FIELD REPORT – LYNNWOOD RECREATION CENTER – FIELD REPORT

REPORT #11

Job No. 10-100622B1

Date: October 15th, 2013

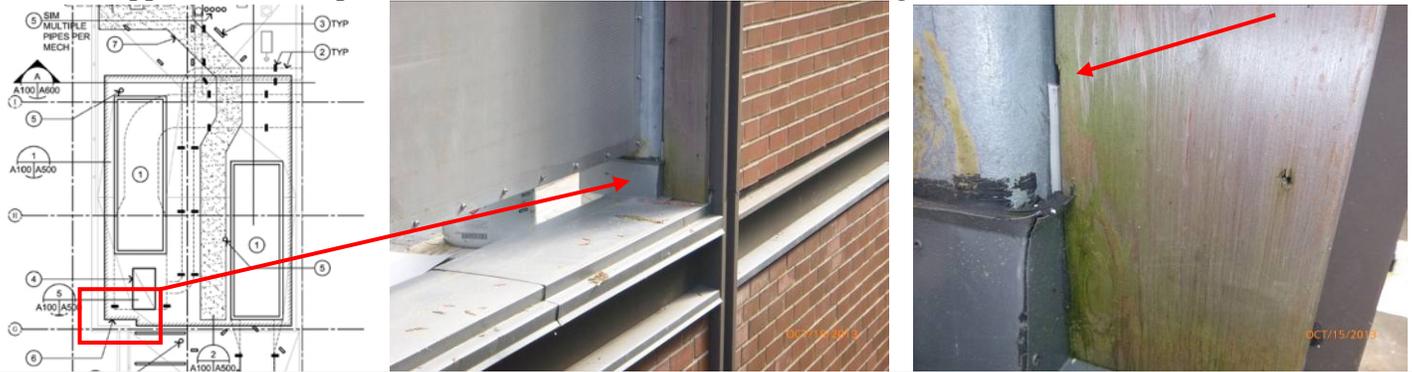
11.4b At the new air handling unit at the west side of the Natatorium Roof the southeast corner of the unit lacks sealant. This unit was manufactured and delivered to the jobsite. Item is noted as an observation.

Roof Progress Plan / Locator Map:

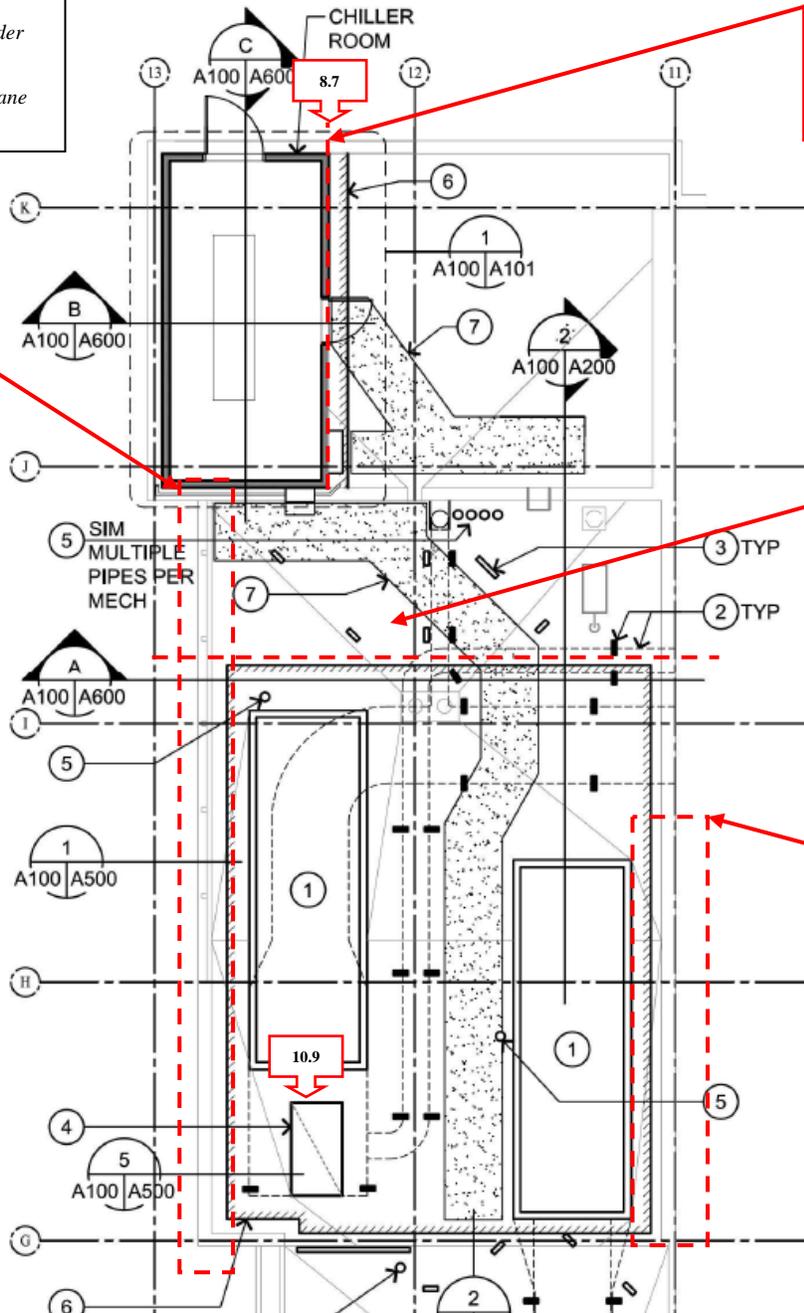
Item 8.4: Infill holes in top plates at screen wall structure.

Problems Item 8.8 – sheet metal re-installation at the upper steep slope roof to accommodate new HVAC.
